SUBJECT: Change Order No. 1 – Contract W-19-9 – 933 Water Tank and Connection Foxconn

933 Water Tank and Connection Foxconn
Change Order 1 Summary

**Racine Water & Wastewater Utility
Louis Sorenson Road Elevated Tank
Engineer: Ruckert & Mielke Inc.**

Value Engineering Proposal #VE19113

APPENDIX 1 - Access Tube / Roof Connection Detail

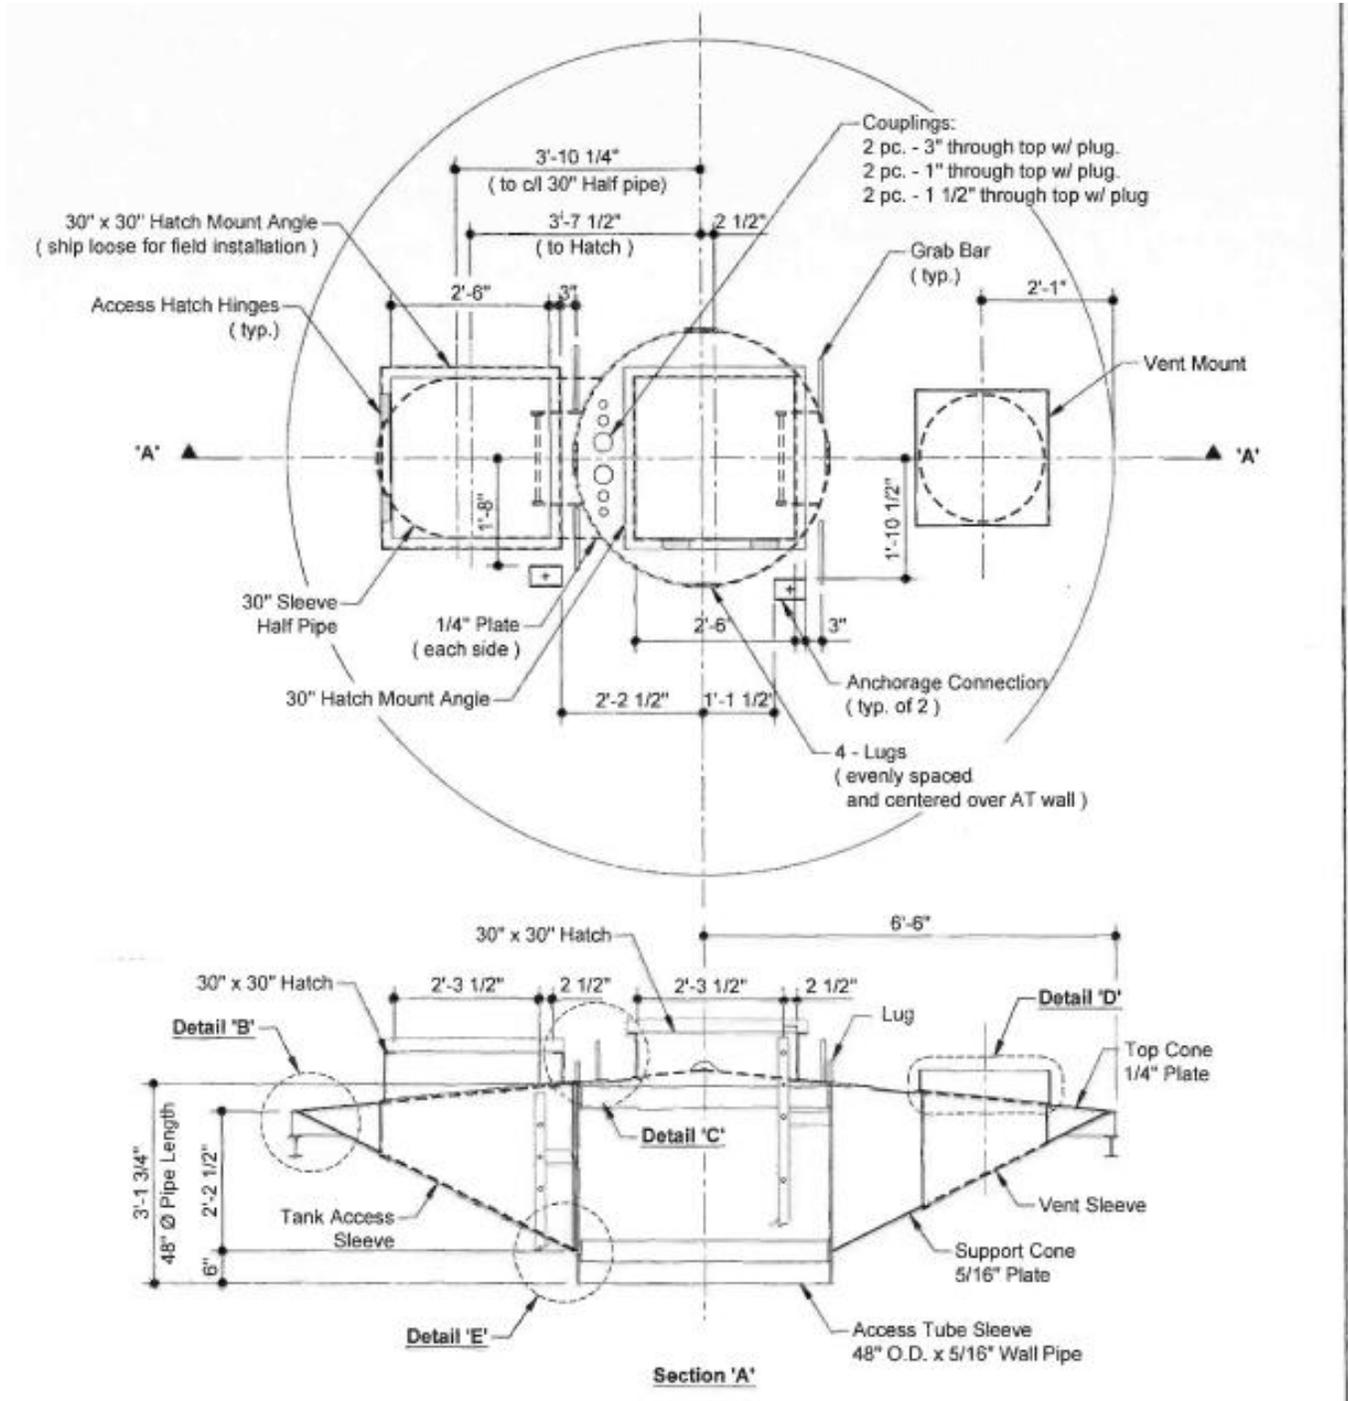
Access Tube / Roof Connection See Appendix 1

Access tube to roof intersection detail is shown.

Landmark proposes our typical detail:

- Maintains standard tank design
- Hatch assembly provides height above roof
- Cleaner appearance

1. **Access Tube Roof/Connections**
Response: Access tube roof connection is acceptable.
2. **Access Tube Hatch Vent**
Response: Access tube hatch vent may be eliminated as long as adequate ventilation is provided in the access tube.

METAL-SPAN BROCHURE

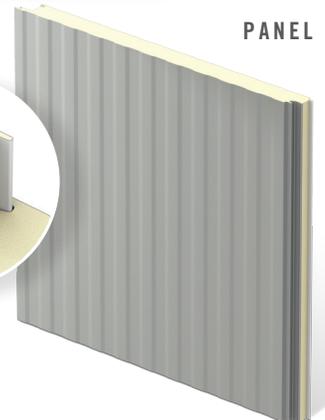
Chamber Room (\$12,000.00)

See Appendix 2

Masonry units are required for chamber room.

Landmark proposes 4" thick Metal-Span panels:

- Pre-insulated
- Brighter cleaner appearance
- Factory baked on finish
- Reduces load differential on slab-on-grade
- Efficient installation
- Quality workmanship
- Thickened slab not required below walls

Response: Stainless steel piping is acceptable.
5. **Chamber Room**
Response: The Utility would like to keep masonry chamber room per plan.
6. **Condensate Drip Ring**

APPENDIX 3 - ACCESS TUBE CONDENSATION RING DETAIL

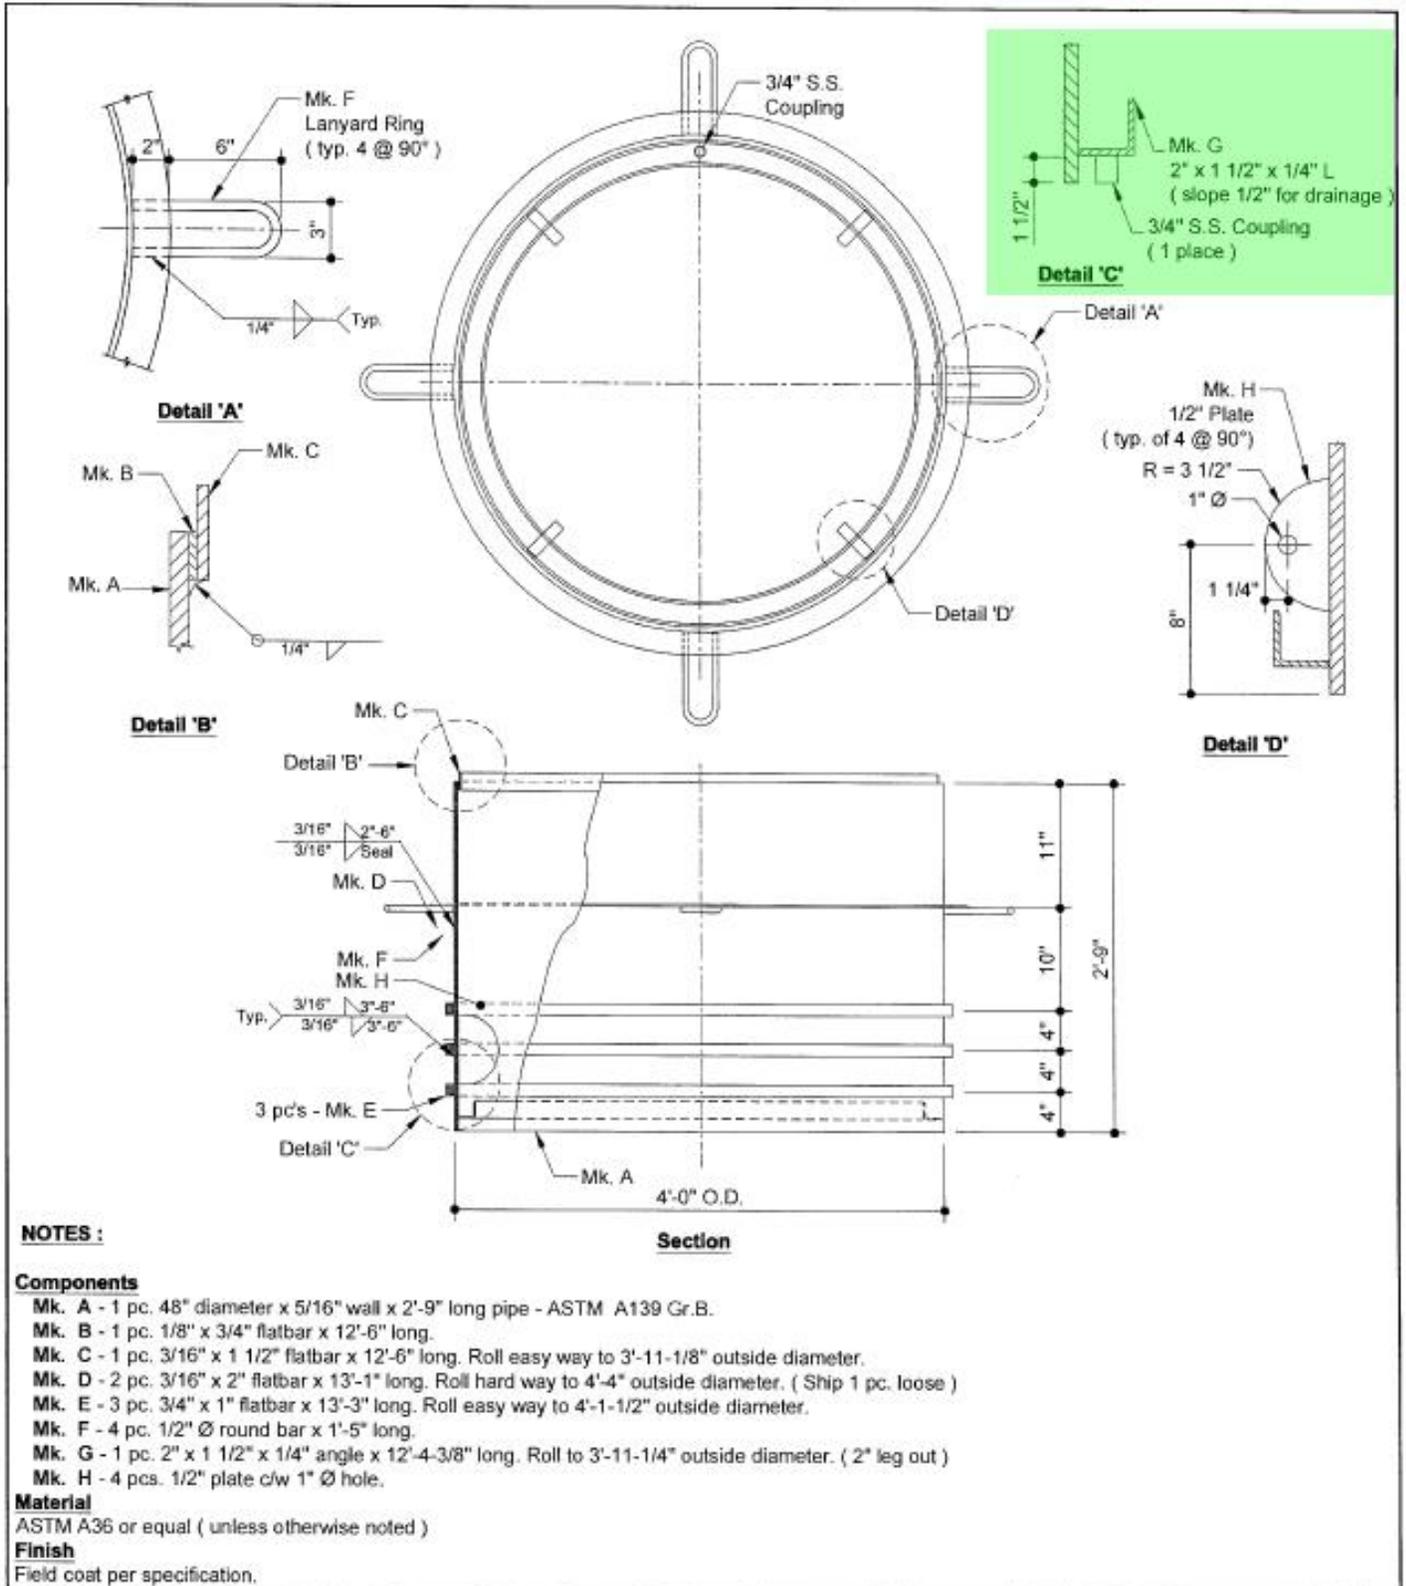
Condensate Drip Ring

See Appendix 3

A condensate drip pan is called out on plans.

Landmark proposes a drip ring:

- More efficient
- Less to maintain
- Works better with access tube design
- Drip pans used when access tube extends to landing

Response: The Condensate Drip Ring is acceptable.
7. **Exterior Backfill**
Response: Waiting on confirmation.
8. **Ladder Safety Rail**
Response: TS Fall Prevention Systems by French Creek are acceptable.

APPENDIX 4 - EARTHWORK SECTION DETAIL

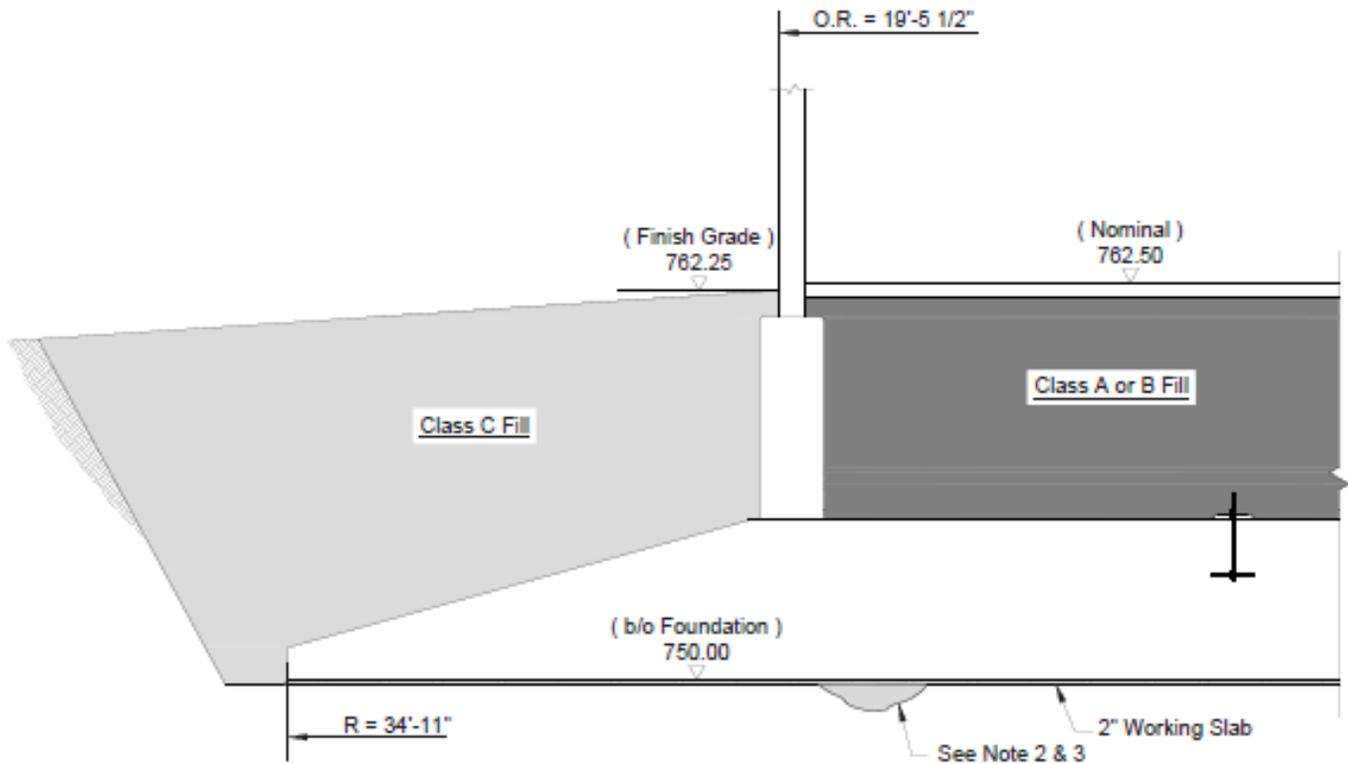
Exterior Backfill

See Appendix 4

3/4" granular base is required for exterior backfill.

Landmark proposes compacted native fill:

- Base holds water with multi-phased backfill
- In accordance with AWWA D107 and industry standards
- Compacted to 95% standard proctor

APPENDIX 8 - Inlet/Outlet Pipe Tank Floor Penetration (1 of 2)

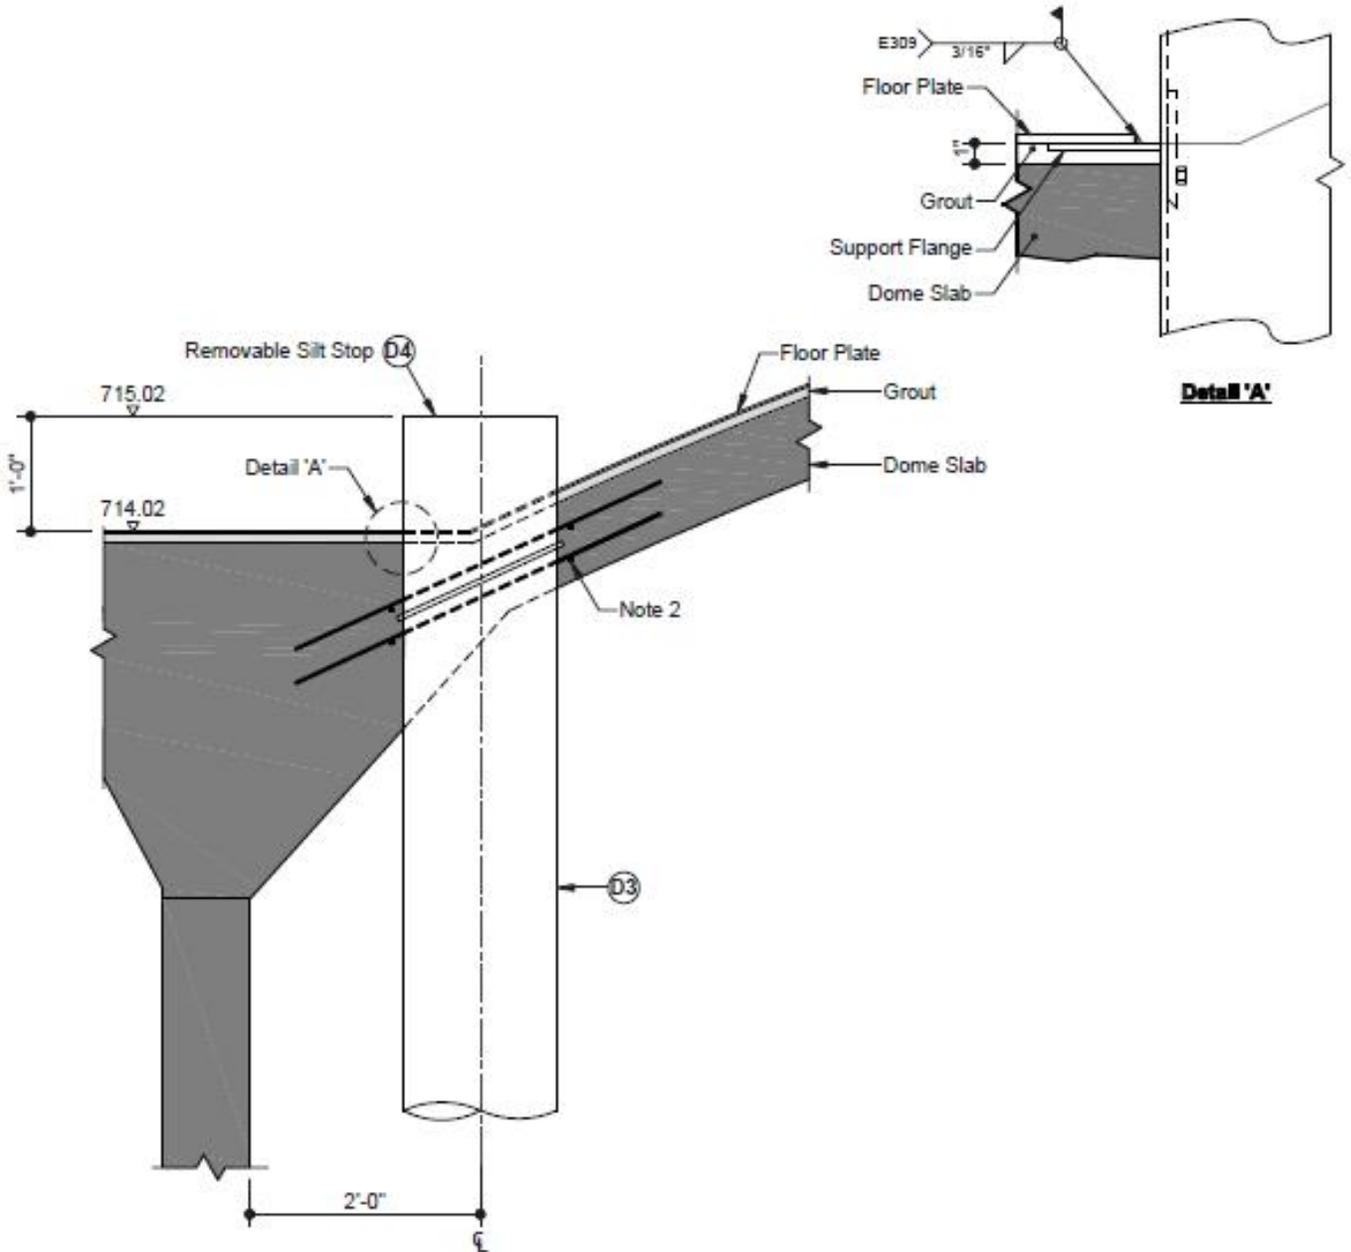
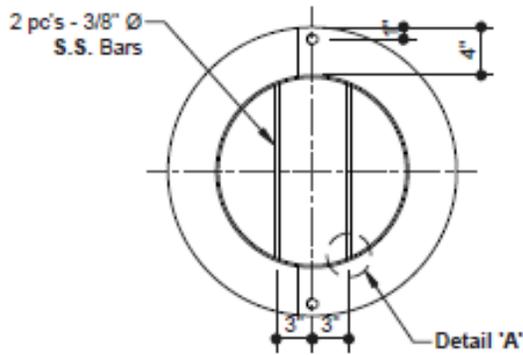
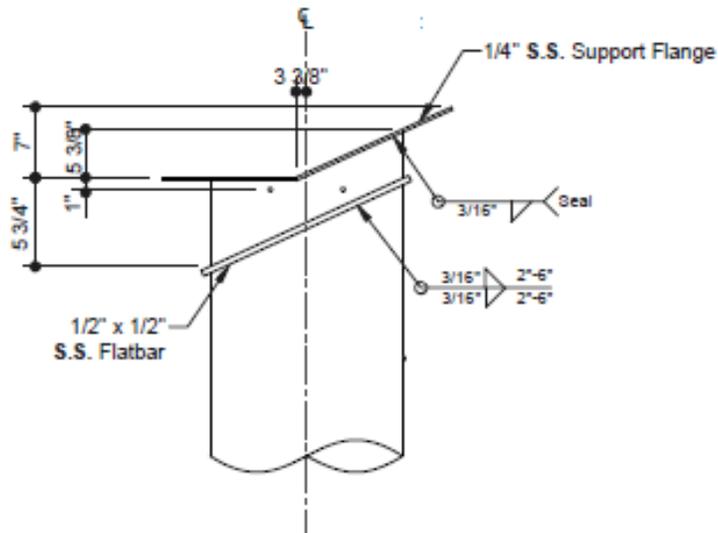
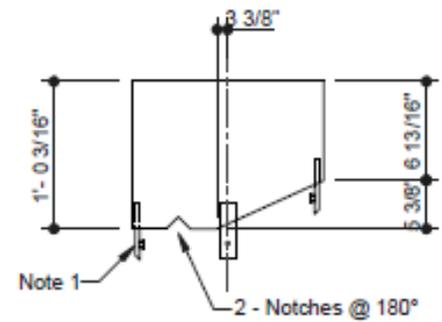
Tank Drain

(See Appendix 8)

Tank drain shown at the low point of tank.

Landmark proposes to remove:

- Inlet/outlet pipe intersects low point of tank
- Drain through overflow crossover valve at grade
- Unnecessary maintenance item

23. **Tank Drain**
Response: Tank drain may be eliminated, as long as the riser is located at the lowest point.
24. **Water Main Encasement**
Response: Terminating encasement below the slab is acceptable.

APPENDIX 9 - WATER MAIN ENCASEMENT DETAIL

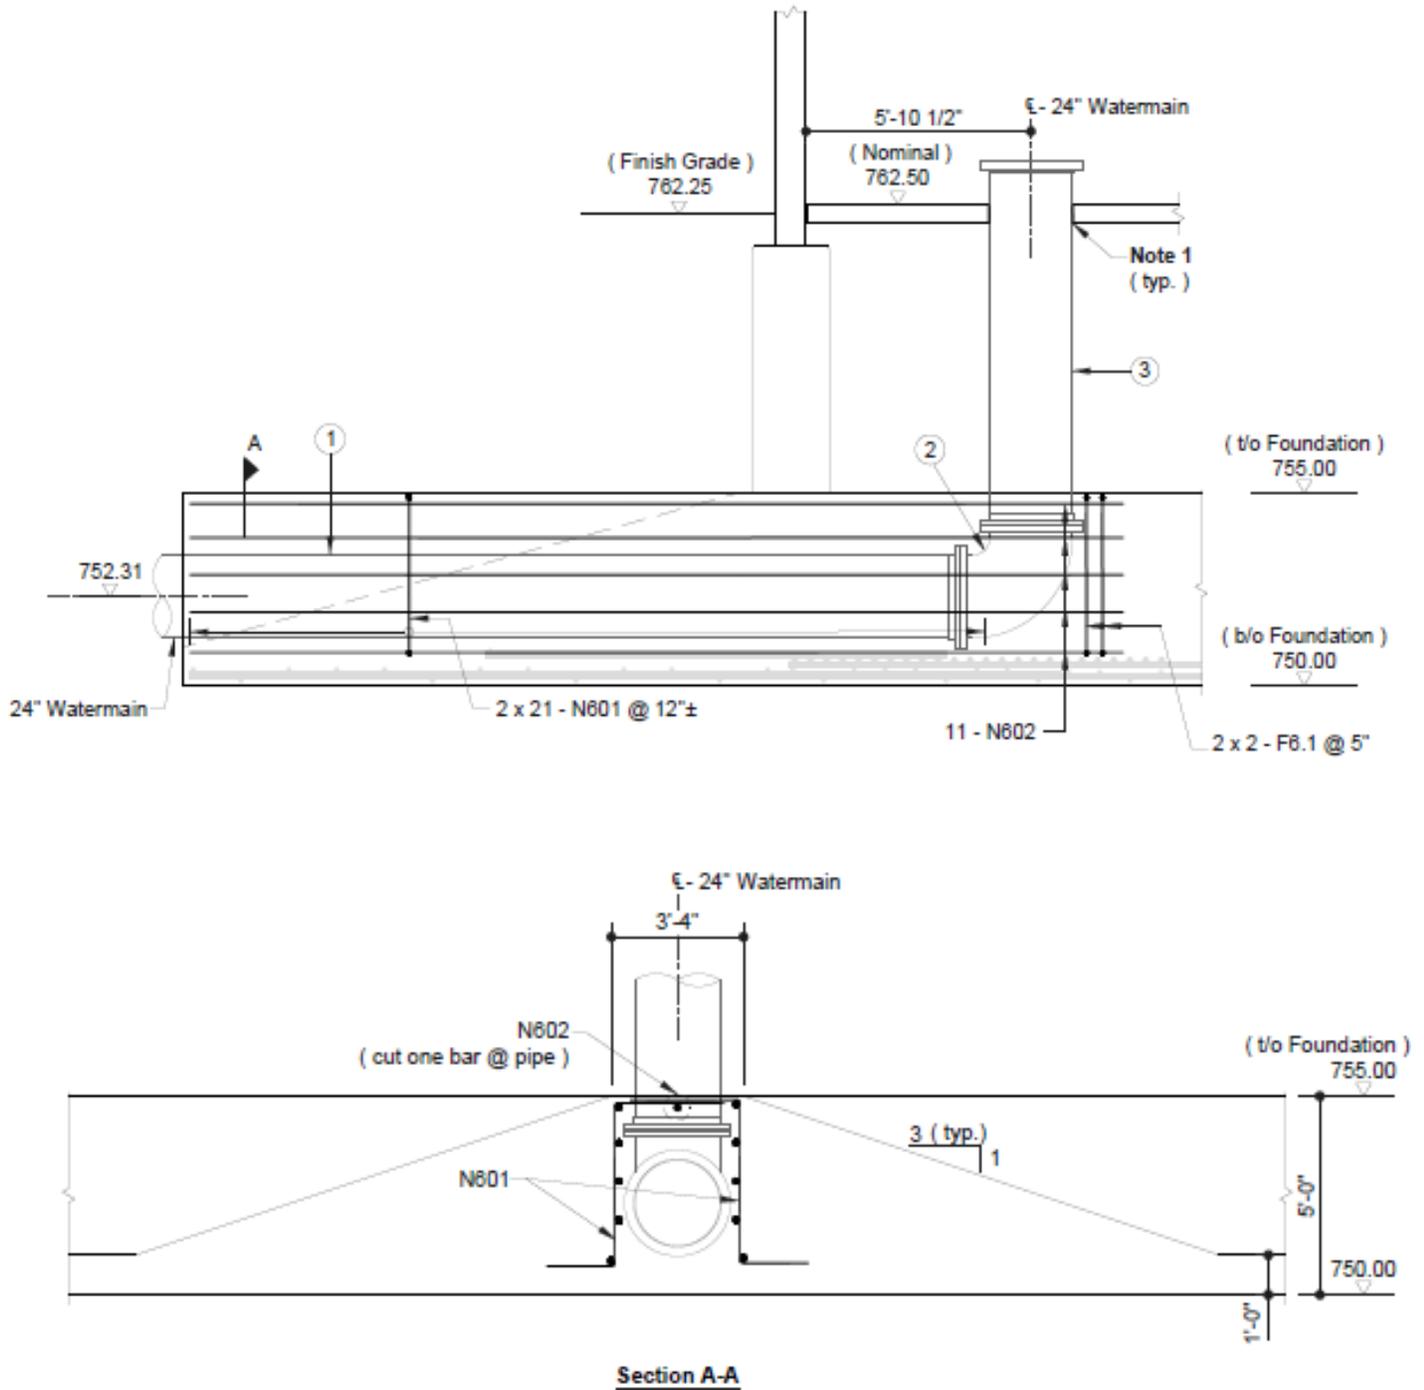
Water Main Encasement

(See Appendix 9)

Encasement shown flush with top of slab.

Landmark proposes to terminate the easement below:

- Avoids differential movement issues
- Slab-on-grade moves independent of structure
